**RÉFECTION DE L'AVENUE LÉOPOLD-COUTURIER
LÉOPOLD-COUTURIER AVENUE UPGRADING
Appel d'offres 2026-079A / Tender Call 2026-079A
ADDENDA 1 / ADDENDUM 1**

ADDENDUM NO. 1

PROJECT NUMBER: 2026-079A

PROJECT NAME: LÉOPOLD-COUTURIER AVENUE UPGRADING

Numéro du dessin : Drawing Number: Rev.
021-26-C1 1

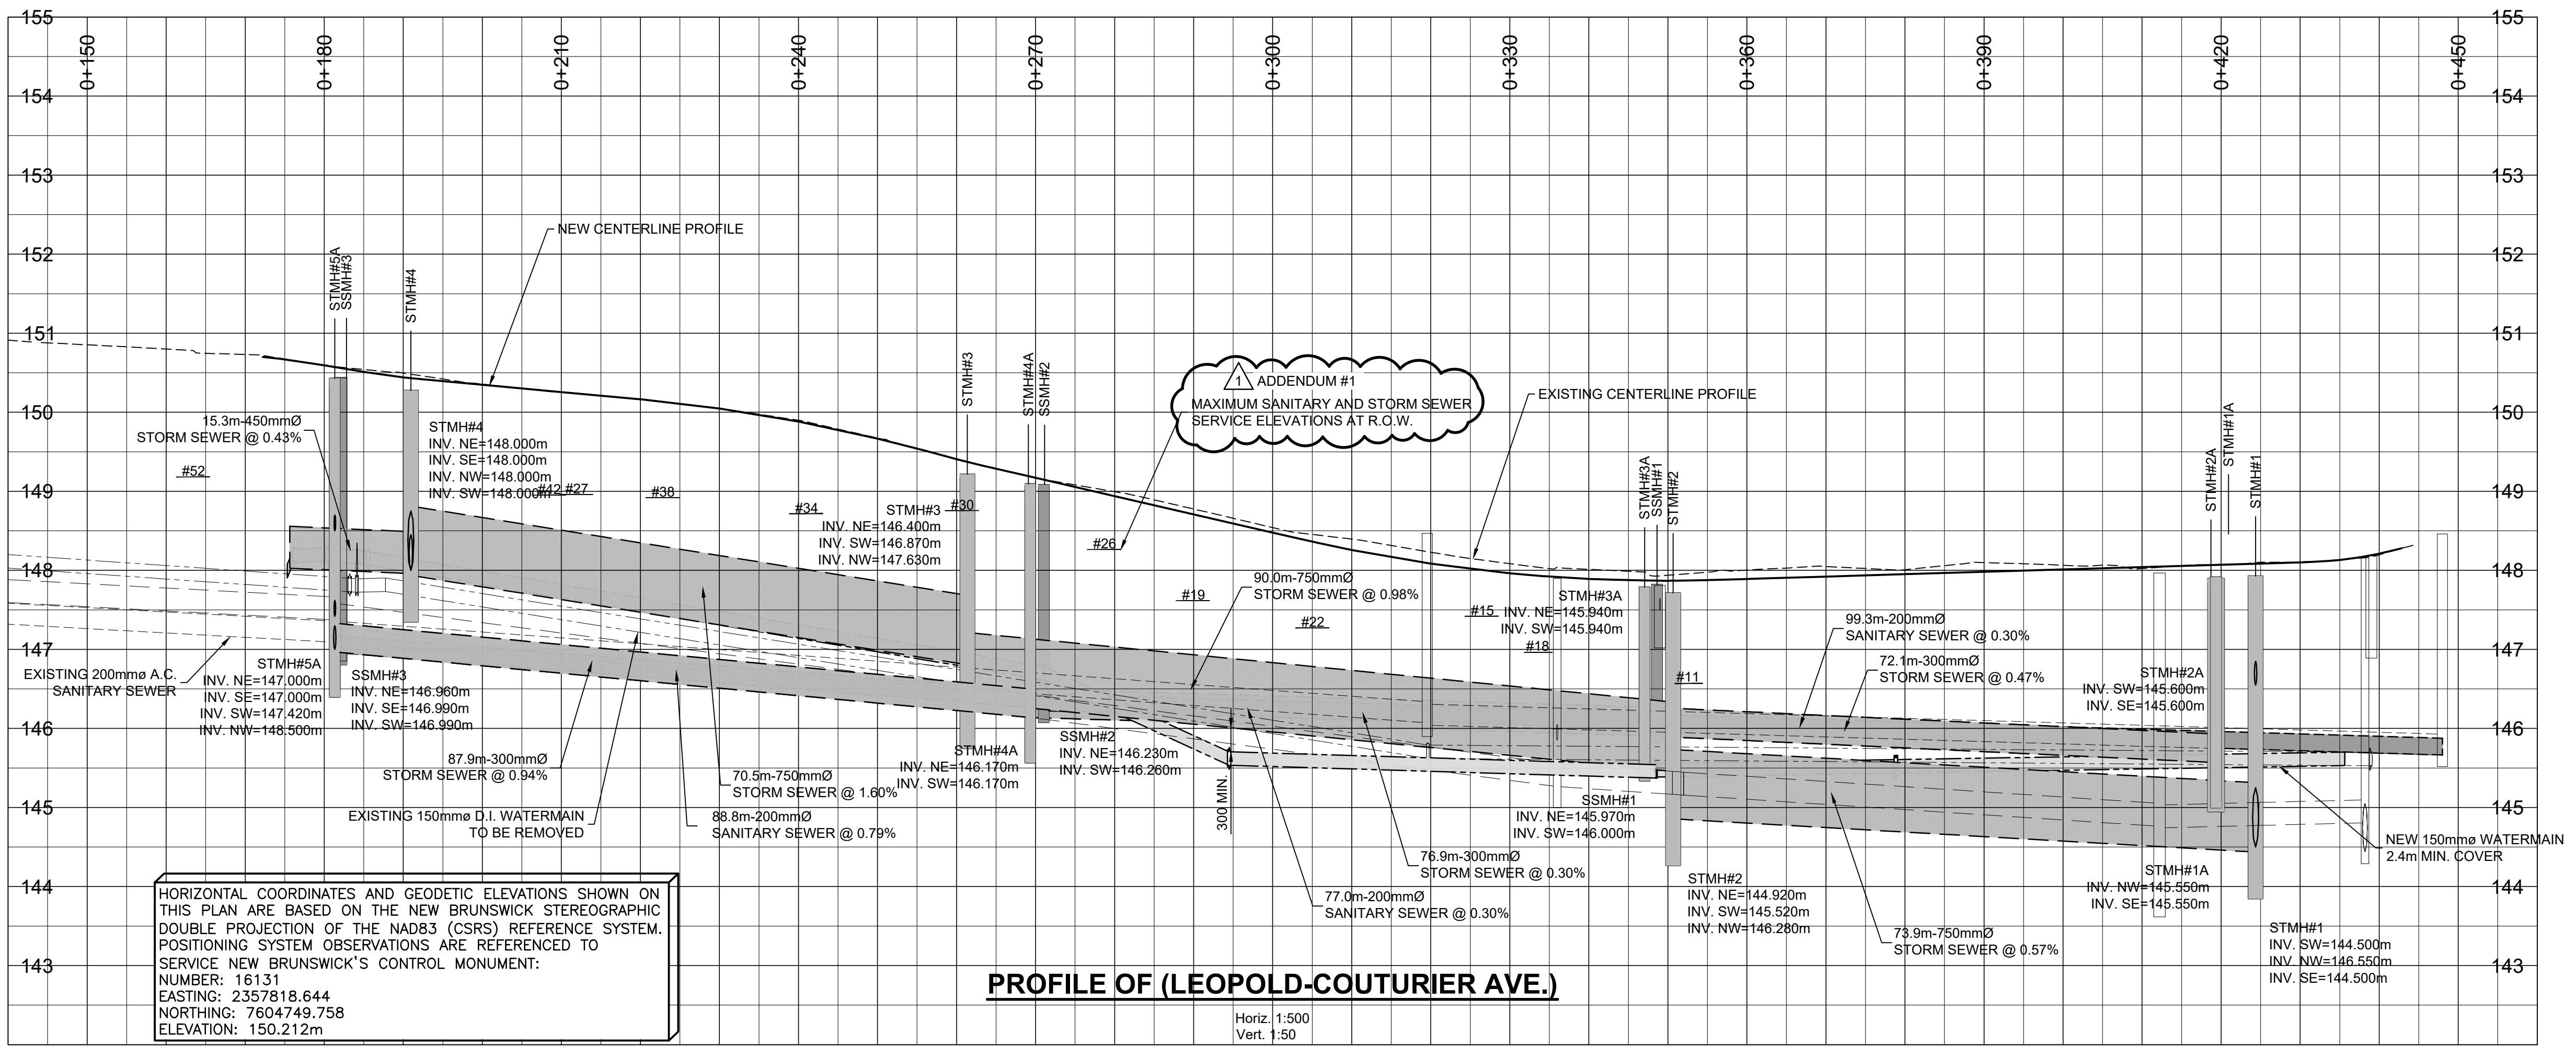
- .1 Replace Drawing 021-26-C1 with the attached drawing 021-26-C1 identified as Addendum no. 1.
